SAFE Notice 2021

Number: 2-4939

Port Waratah (Waratah to Sandgate)

Commissioning of Re-signalling

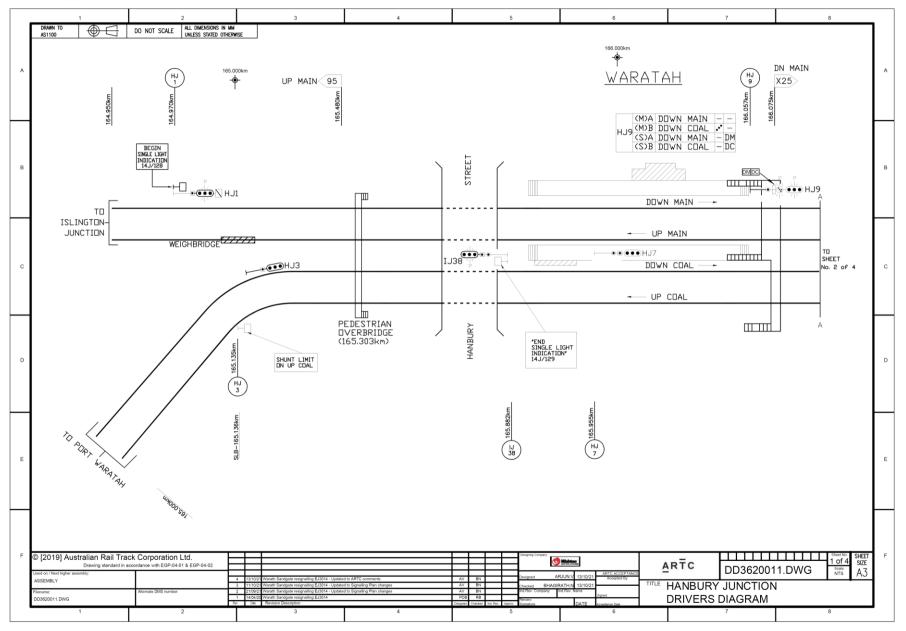
Delete: NIB Diagram NIB-T0370

Drivers Diagram of the layout (pending Update to NIB Diagram (NIB-T0370) and NIB Line Diagram (NIB-T0582)) is provided as an attachment to this SAFE Notice.

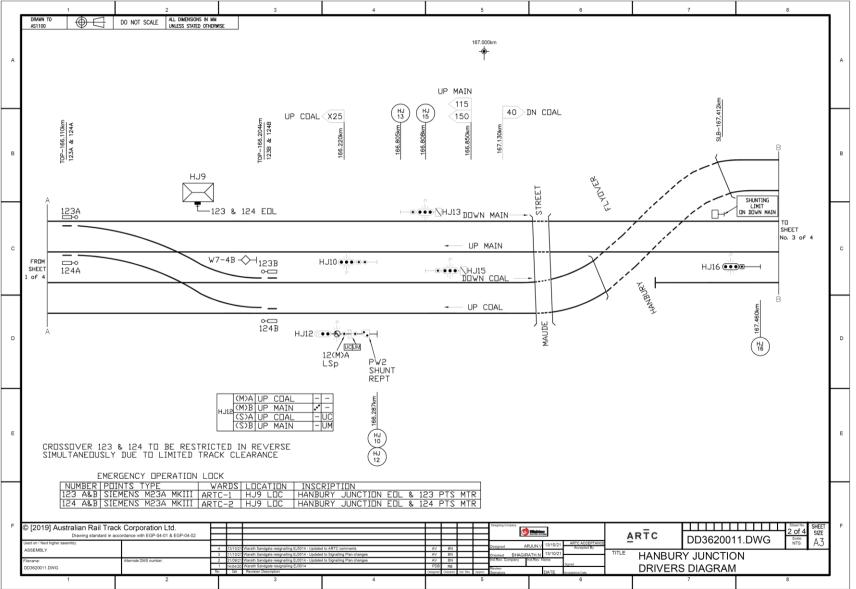
Delete: NIB Diagram NIB-T0375

Drivers Diagram of the layout (pending Update to NIB Diagram (NIB-T0375) and NIB Line Diagram (NIB-T0583)) is provided as an attachment to this SAFE Notice.

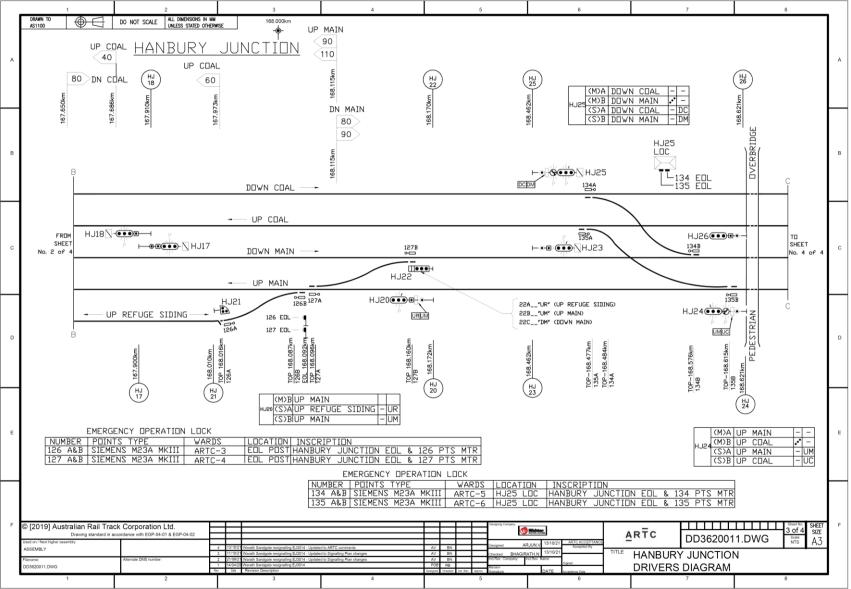
Delete: NIB Diagram NIB-T0376

Drivers Diagram of the layout (pending Update to NIB Diagram (NIB-T0376) and NIB Line Diagram (NIB-T0583)) is provided as an attachment to this SAFE Notice.

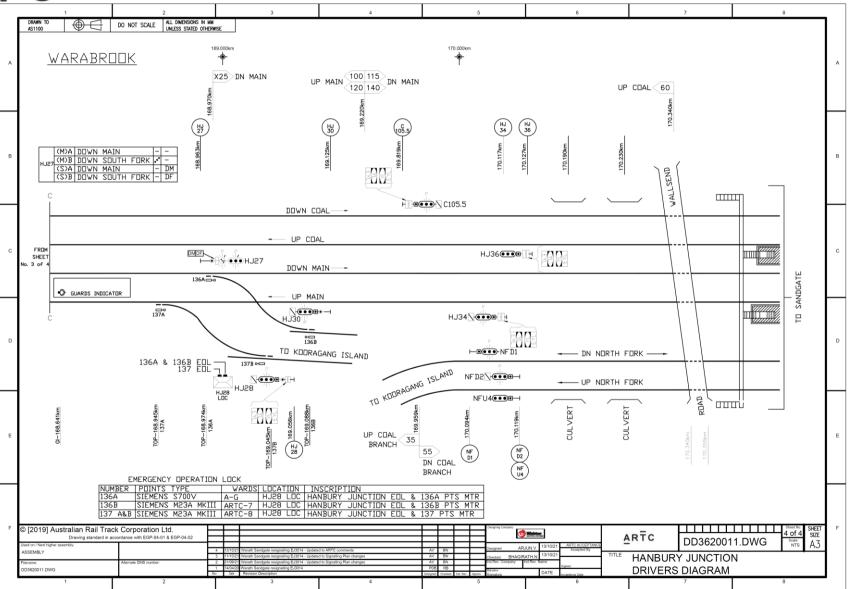
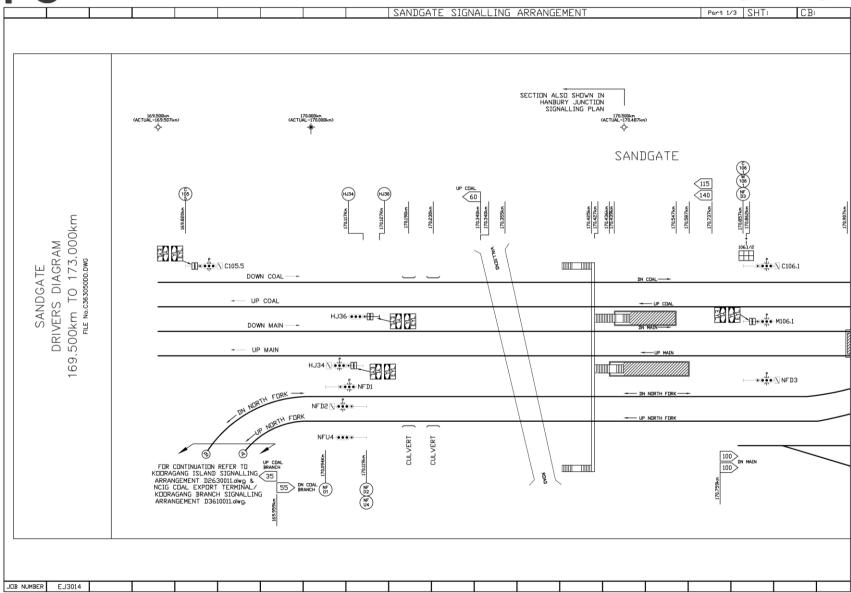
Delete: NIB Diagrams NIB-T0377 and NIB-T0378

Drivers Diagram of the layout (pending Update to NIB Diagrams (NIB-T0377 and NIB-T0378) and NIB Line Diagram (NIB-T0583)) is provided as an attachment to this SAFE Notice.

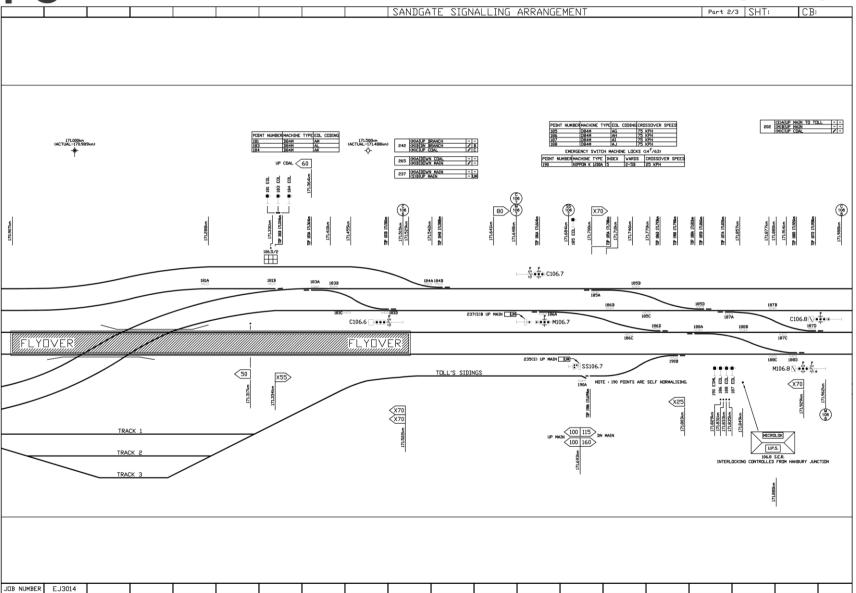
Delete: NIB Diagram NIB-T0379

Drivers Diagram of the layout (pending Update to NIB Diagram (NIB-T0379) and NIB Line Diagram (NIB-T0583)) is provided as an attachment to this SAFE Notice.

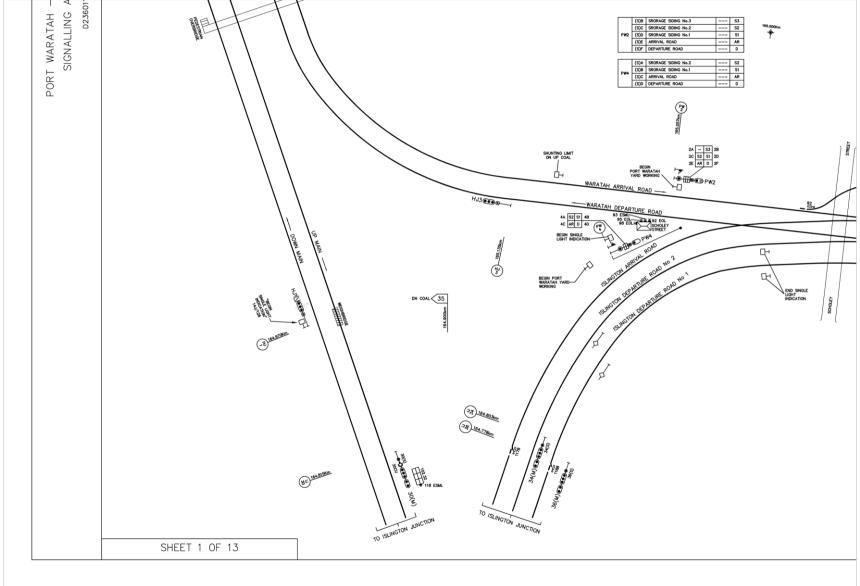
Delete: NIB Diagram NIB-T0381

Drivers Diagram of the layout (pending Update to NIB Diagram (NIB-T0381) and NIB Line Diagram (NIB-T0584)) is provided as an attachment to this SAFE Notice.
